SANDIA REPORT

SAND2014-2647
Unlimited Release
Printed April 2014

Review of Inputs Provided to Jason Associates Corporation in Support of RWEV-REP-001, the *Analysis of Postclosure Groundwater Impacts* Report

Figure 1. Groundwater pumping estimates (in acre-feet) for the Amargosa Desert generated by the State of Nevada, Division of Water Resources between 1983 and 2012.

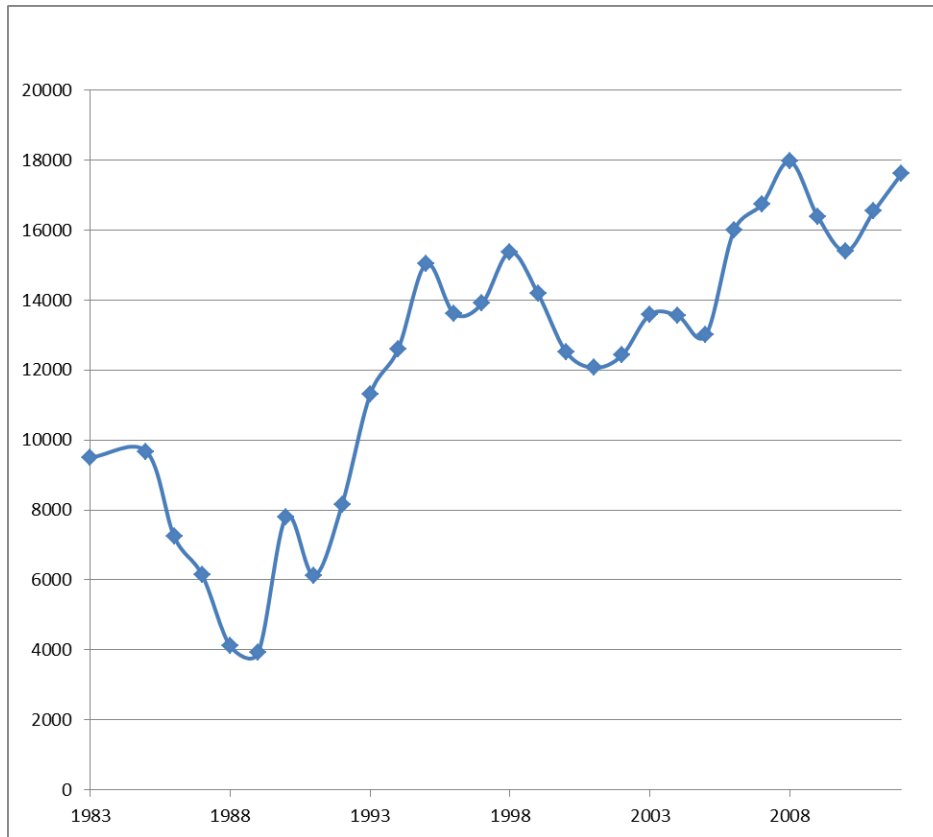
The 2009 *Groundwater Impacts* report DVRFS calculations used total groundwater pumping rates for the Amargosa Valley of 14,100–21,200 acre-feet per year from 1994 to 2003, averaging 16,800 acre-feet per year. These data are based on USGS estimates of groundwater withdrawal in the Valley. While more recent estimates of pumping rates by the USGS have not been published, the State of Nevada, Division of Water Resources (NVDWR) has published additional data (see, Amargosa Valley No. 230, <http://water.nv.gov/data/pumpage/?basin=230>, last retrieved 3/10/2014); these data are shown in Figure 1. NVDWR estimates of groundwater withdrawal rates from 2006 to 2012 range from 15,400 to 18,000 acre-feet per year, averaging 16,700 acre-feet per year. This value closely matches the value used in the 2009 *Groundwater Impacts* report.

It is important to note that the USGS pumping estimates for the Amargosa Valley have in the past been slightly higher than the groundwater withdrawal rates calculated by the NVDWR, using the same USGS source data but a different approach for estimating irrigation rates in the absence of data (see RWEV-REP-001, p. 2-16). However, since the State of Nevada data constitute the only available data for the post-2003 period, they are appropriate for use to validate the range used in the 2009 report. On the basis of this comparison, there is no need to update the DVRFS modeling done in the *Groundwater Impacts* report to capture more recent pumping data.
